CITY PLAN COMMISSION**THURSDAY, MAY 2, 2024****FILE NUMBER:** S234-082**SENIOR PLANNER:** Sharmila Shrestha**LOCATION:** Roseland Avenue at Peak Street, south corner**DATE FILED:** April 3, 2024**ZONING:** PD 298 (Subarea 1)**PD LINK:** [Article 298.pdf \(dallascityhall.com\)](https://dallascityhall.com/Article%20298.pdf)**CITY COUNCIL DISTRICT:** 2**SIZE OF REQUEST:** 0.213-acre**APPLICANT/OWNER:** Geoffrey Wattiker

REQUEST: An application to replat a 0.213-acre tract of land containing part of Lot 10 and all of Lot 10A in City Block 3/649 to create one lot on property located on Roseland Avenue at Peak Street, south corner.

PRELIMINARY PLAT

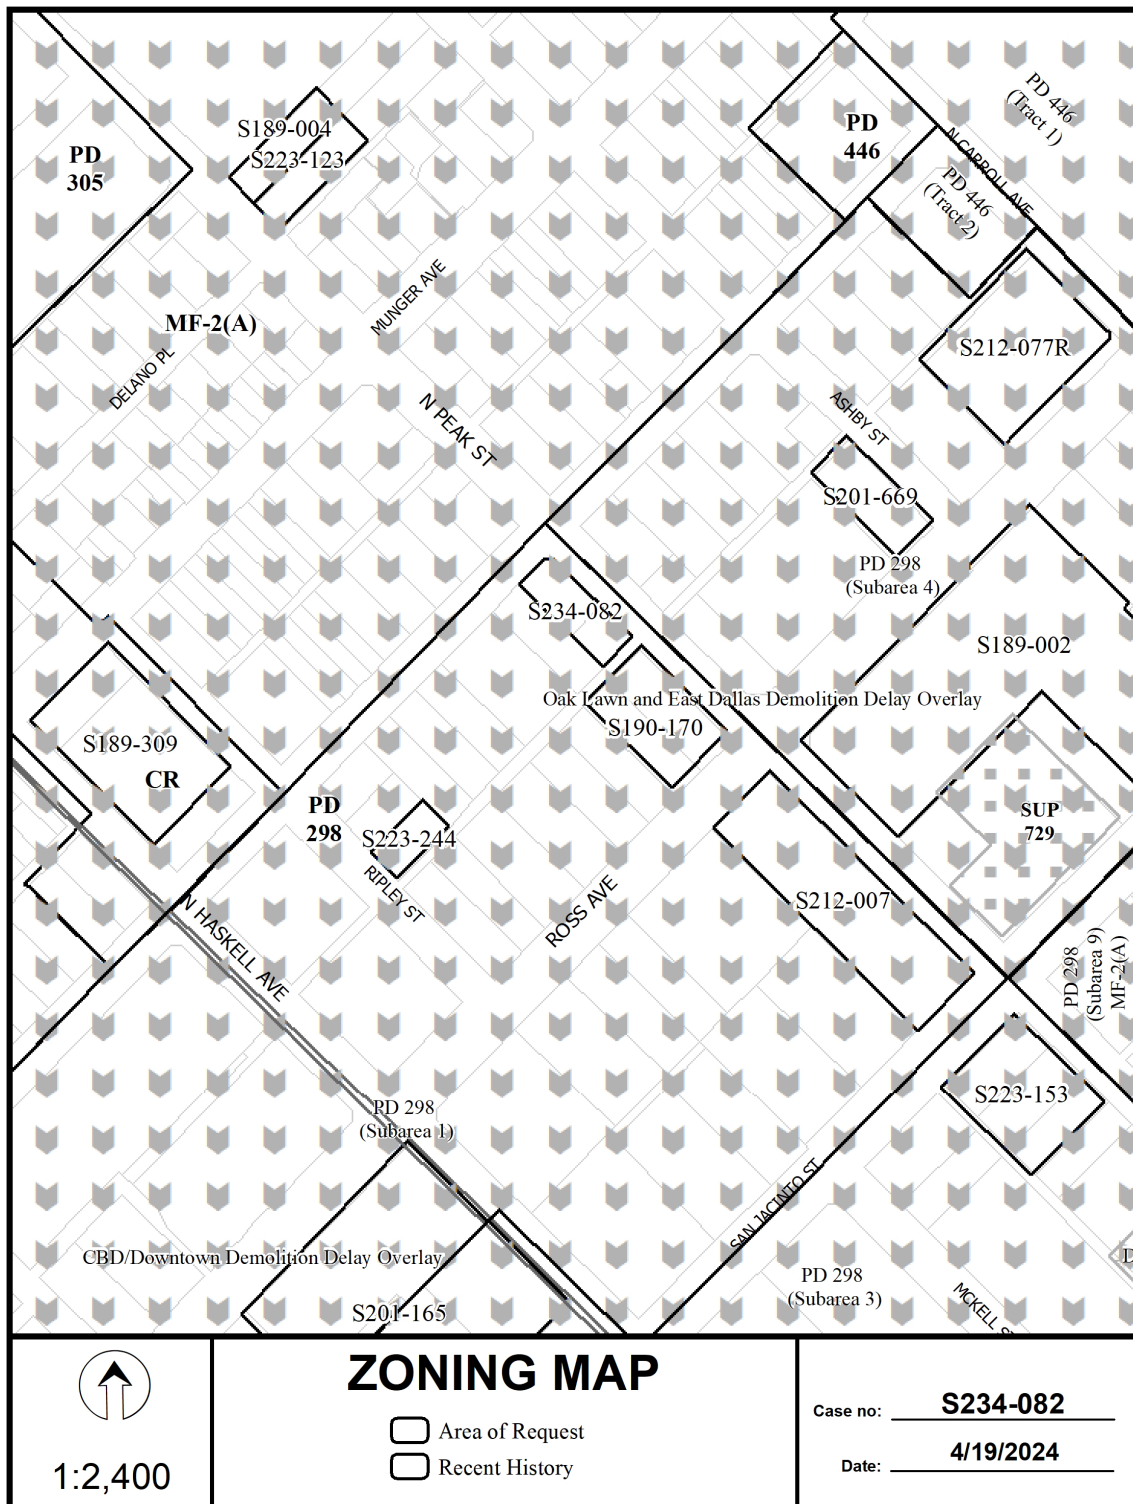
15. On the final plat, dedicate 15-foot by 15-foot alley sight easement at Peak Street and Alley. Section 51A-8.602(e)
16. Comply with Mill Creek drainage requirements. Finish floor elevation must be 3' above nearest inlet, top of curb. 51A 8.611(d), C.9 of Mill Creek, Master Drainage Plan Study

23. On the final plat, change “Rosss Avenue” to “Ross Avenue”.
24. On the final plat, change “FKA Flora Street Roseland Avenue” to “Roseland Avenue (FKA Flora Street)”.
25. On the final plat, identify the property as Lot 10B in City Block 3/649.
